### **ADDENDUM #3**

#### **Rye City School District**

***Issued: 2021-02-11***

**This Addendum No. 3 forms part of the Contract Documents and modifies the original bidding documents dated, January 19, 2021.**

**WORK NOTES:**

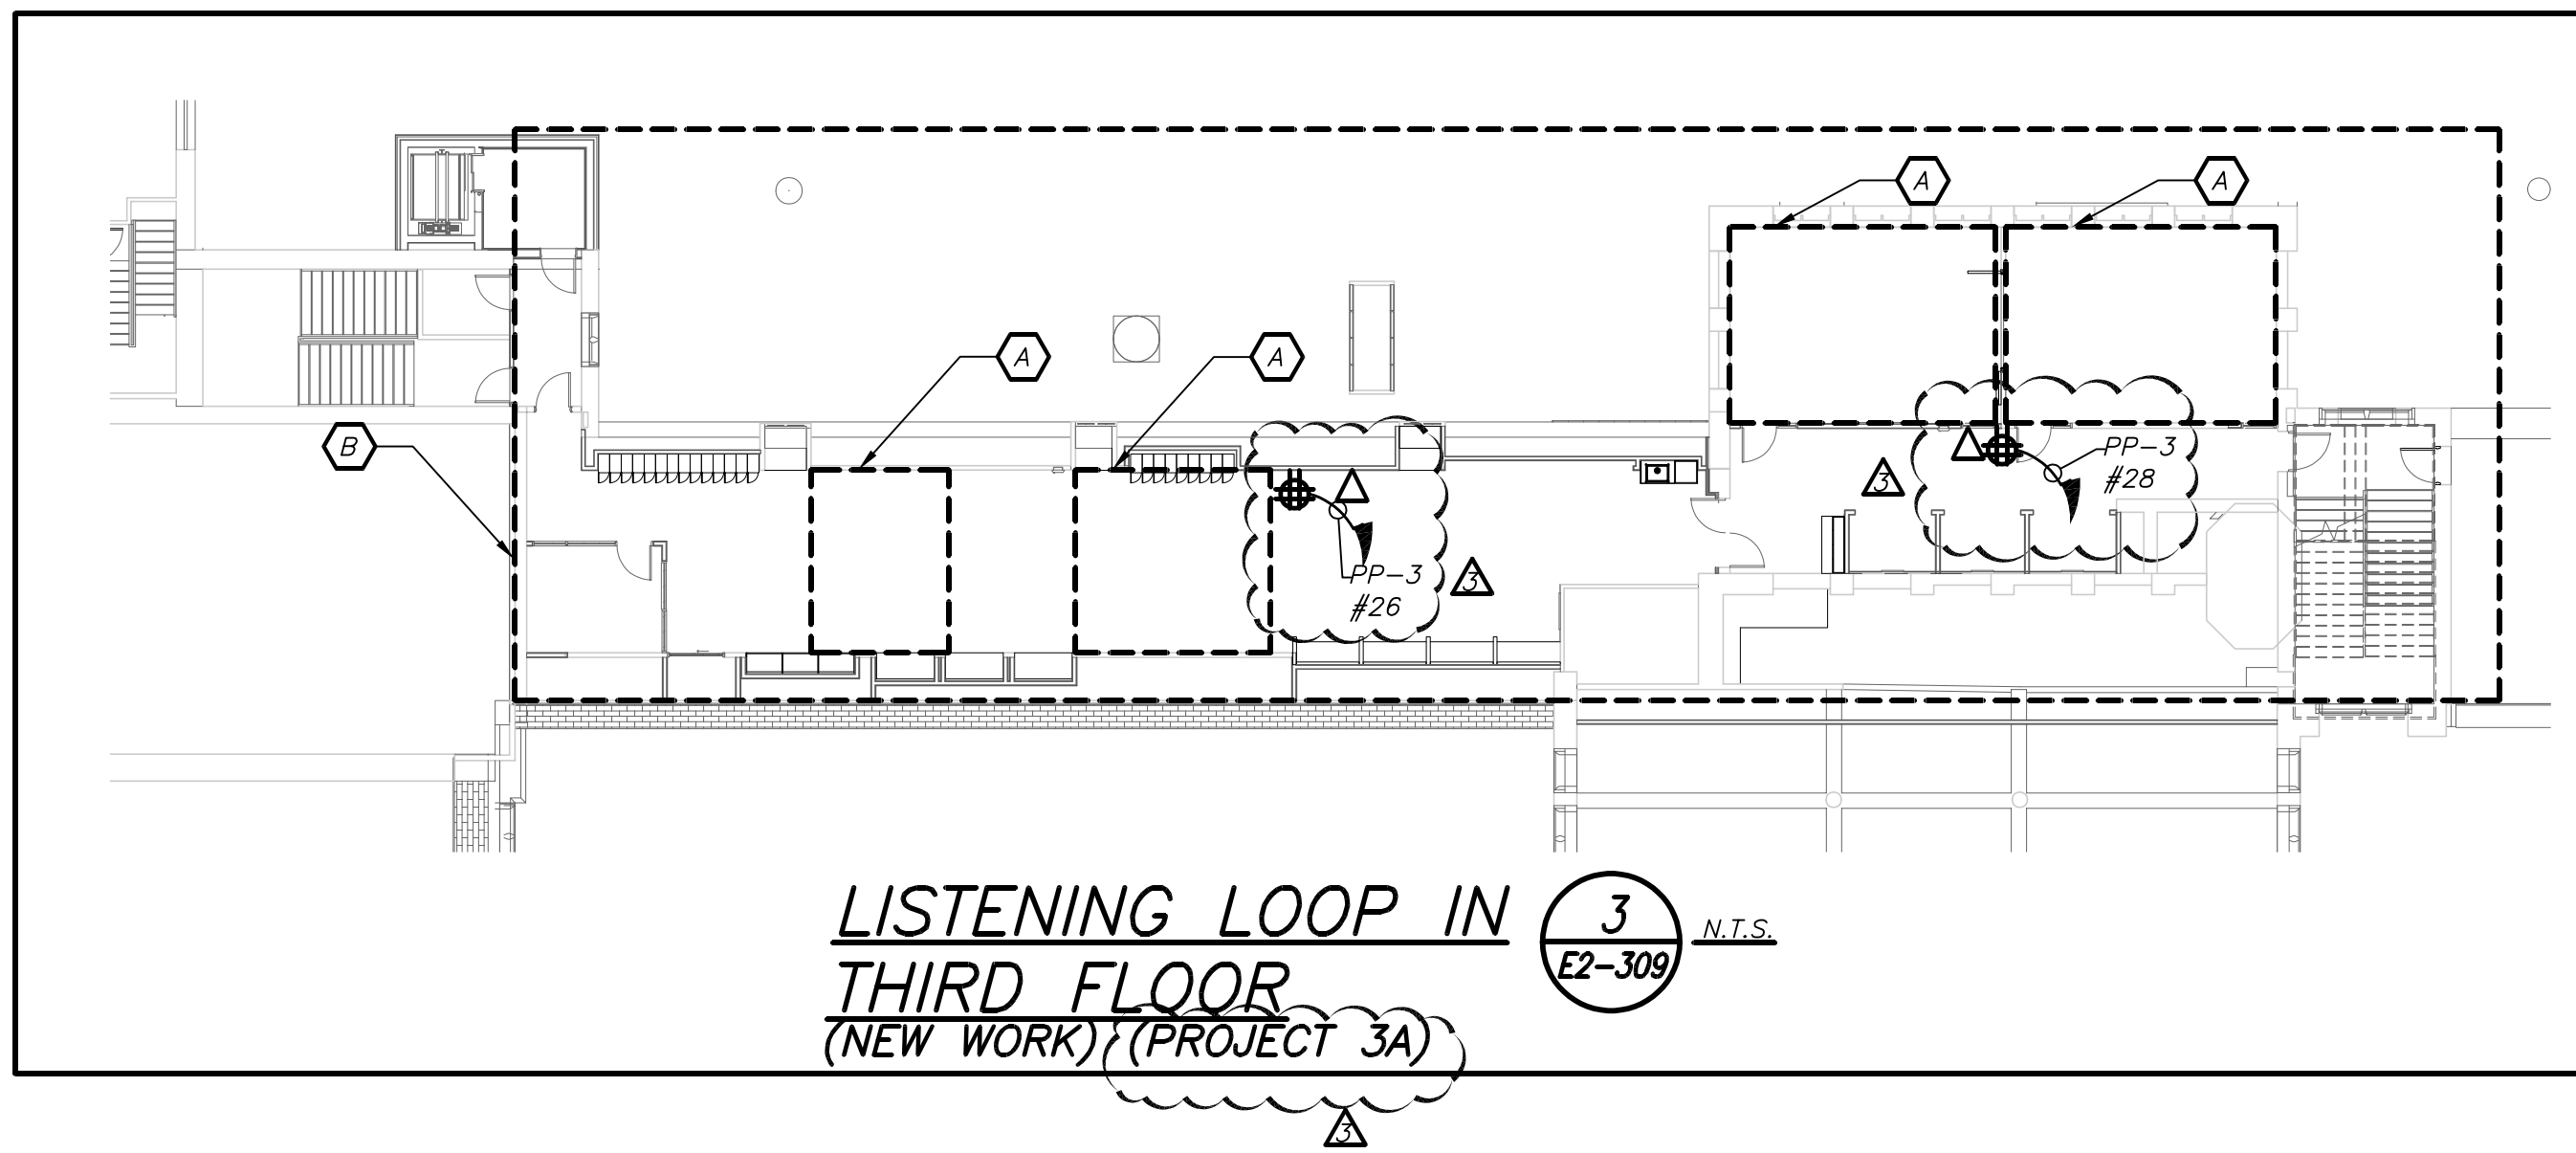
- a. All work related to the Telecoil Loop shall be “Project 2A.”
- b. Provide data drop for Telecoil Loop Headend.
